7 ACORN STREET
BEACON HILL
BOSTON MA

PROGRESS SET FOR REVIEW

BEACON HILL ARCHITECTURAL
COMMISSION APPLICATION

Brick Moulding Profiles

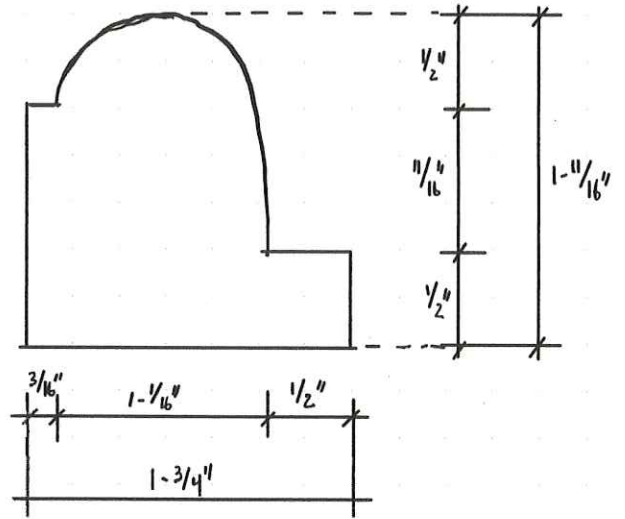
- **SCOPE OF WORK:** Please confirm in writing whether or not the existing storm windows are to be retained...if you are proposing to install insulated windows it is recommended that the exterior storm windows be removed permanently. Also confirm whether or not the existing wood brick molds are to be retained and restored, or replaced in-kind. If they are to be replaced then you will need to make sure that both your existing and proposed window drawings reflect the accurate profile of the historic wood brick mold.

While every effort will be made to reuse the existing wood brick molds, it is likely that they will need to be replaced when the old windows come out. If this is the case, we intend to match the existing brick mold in kind with the same profile. Here is a photo of the existing brick mold and our best guess at the profile. Once we are able to cut out a piece and clean off layers of paint, we will match exactly:

Section Through Roof Deck Parallel to Building

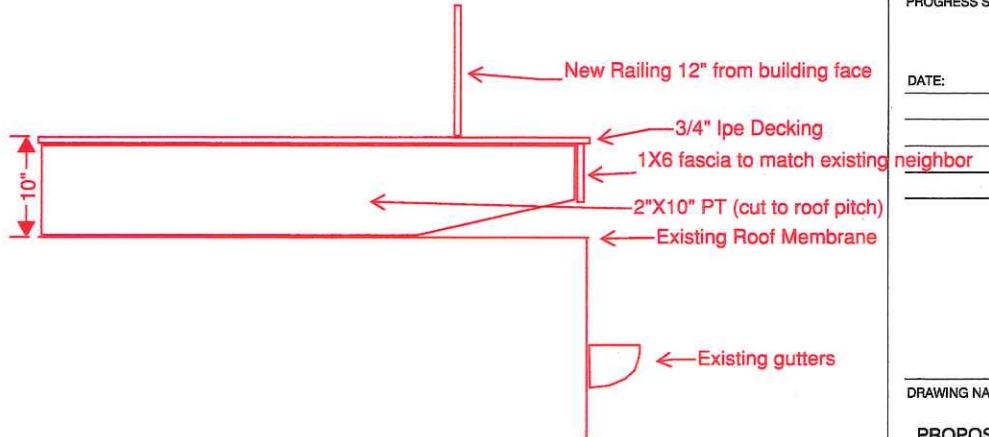
- DRAWINGS: *Need dimensioned roof plan, section and elevation drawings detailing the setbacks from the facades and heights from the finished roof.*

- *From the submitted photographs, it appears that the existing roof deck is made of wood with wood railings. It is recommended that the proposed replacement roof deck have metal railings with a dark finish that have a smaller profile to help reduce the visibility.*

- *The Commission will be interested in the details of the deck apron/fascia given the level of visibility (hence the need for the elevation and section drawings). If the existing roof deck is right at the edge of the rear facade I'd consider pushing it back a little bit to help break up the massing.*

Please see attached drawings

We will replace the wood railing with a metal railing painted black to match the profile and color of the adjoining roof deck (see previous photo)

We would be happy to pull the roof deck in 1' from both roof edges to break up the massing. See attached plan and profile/section

Pull railing back 12" to reduce overall massing from street

REPLACE EXISTING RAILING WITH NEW METAL RAILING to match adjoining roof deck (see photo)

Since these two units were originally one residence, we feel it would be most appropriate to continue the same size apron/fascia (1X6) as the neighboring roof deck to reduce the massing (currently 1X10 fascia) and create a sense of uniformity
